DEPARTMENT OF GENERAL SERVICES
BUREAU OF CAPITAL PROJECT DESIGN MANAGEMENT
1800 HERR STREETS
HARRISBURG, PENNSYLVANIA

ADDENDUM NO. 6

PROJECT NO. DGS C-0199-0045 PHASE 001
PROJECT TITLE - Lower Woods Pond - Renovate Dam
PROFESSIONAL:

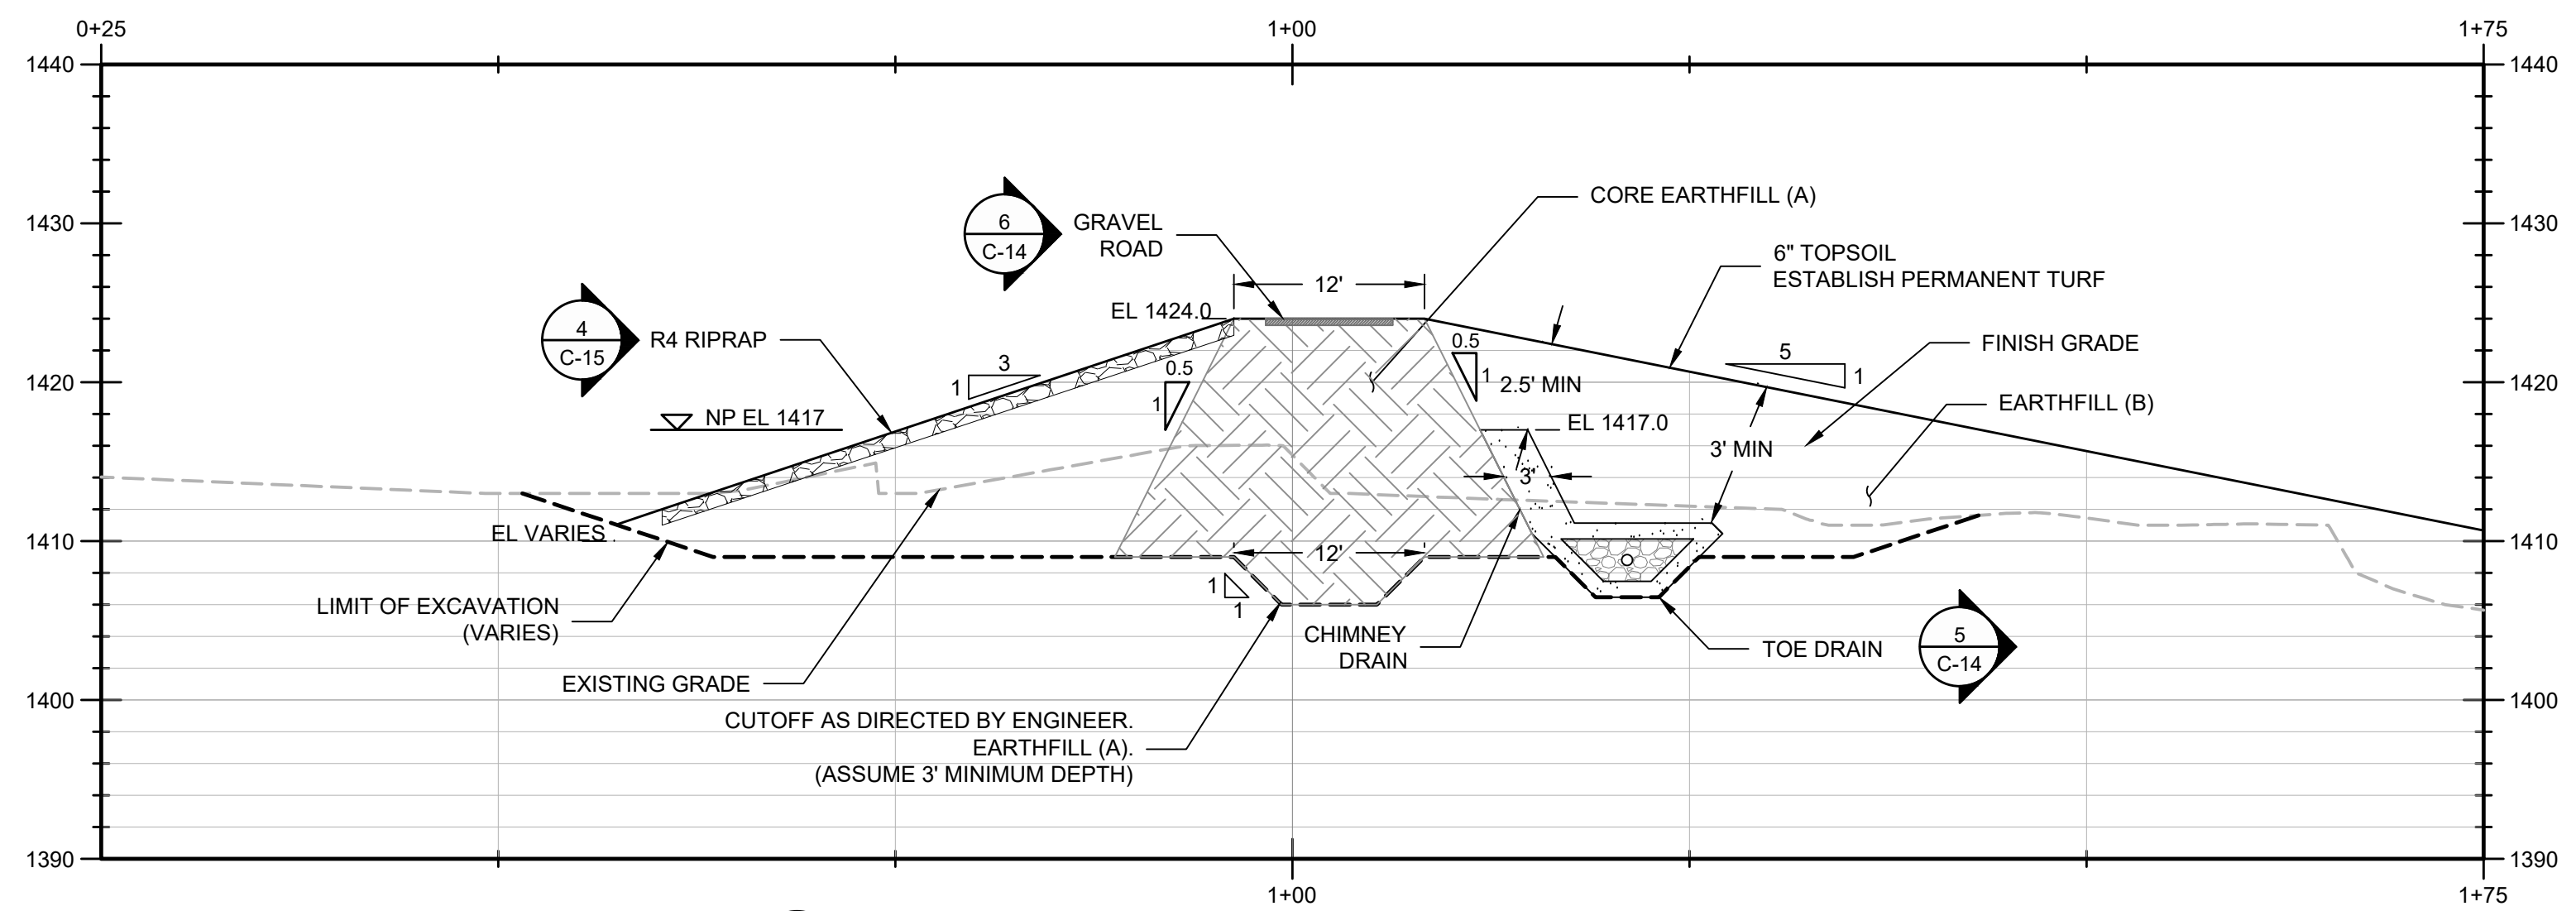
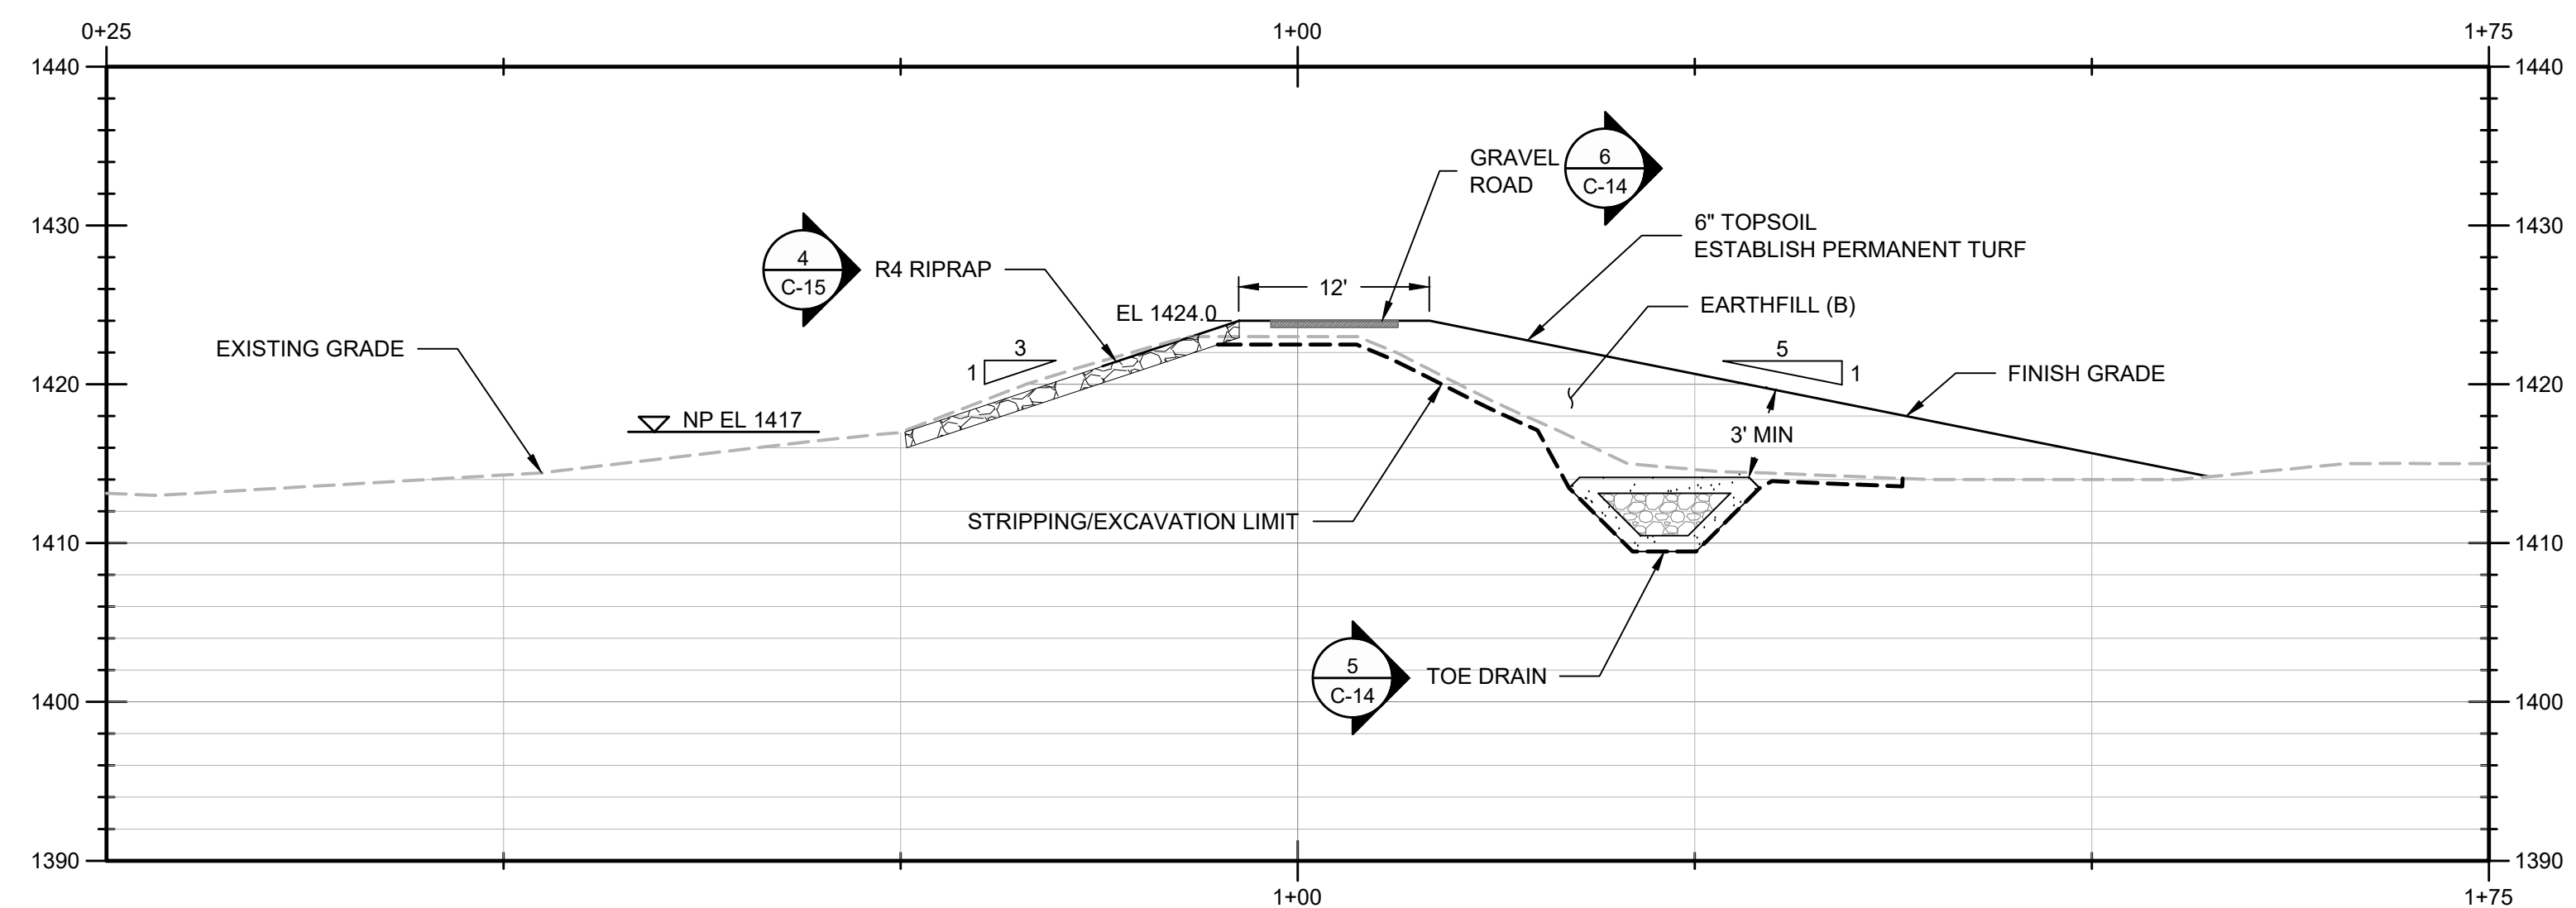
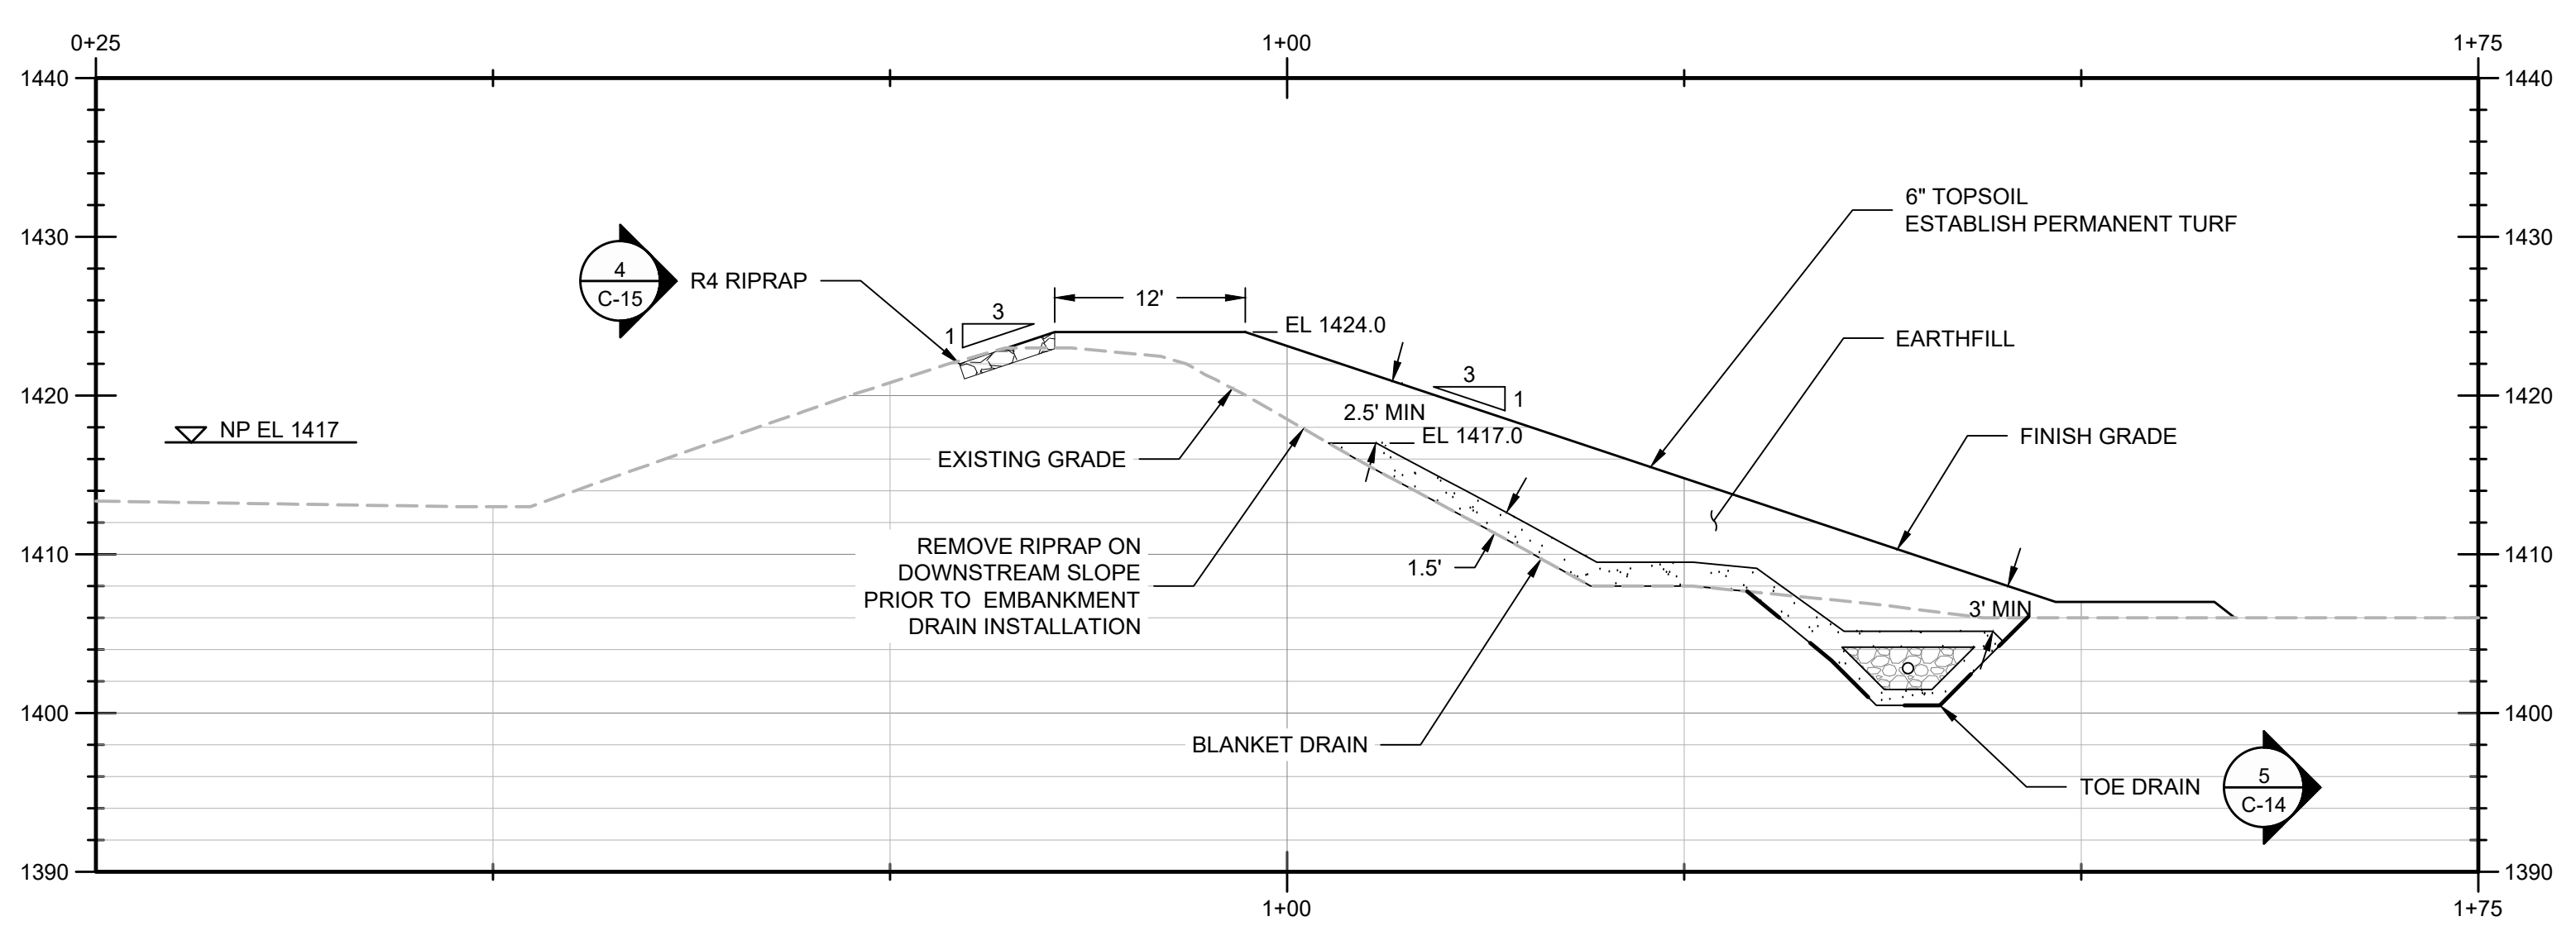
Item 1 - Drawing C-15, Embankment Sections - Dams 2 & 3: REPLACE Drawing C-15 with revised drawing C-15 attached to this addendum. Stationing has been revised.
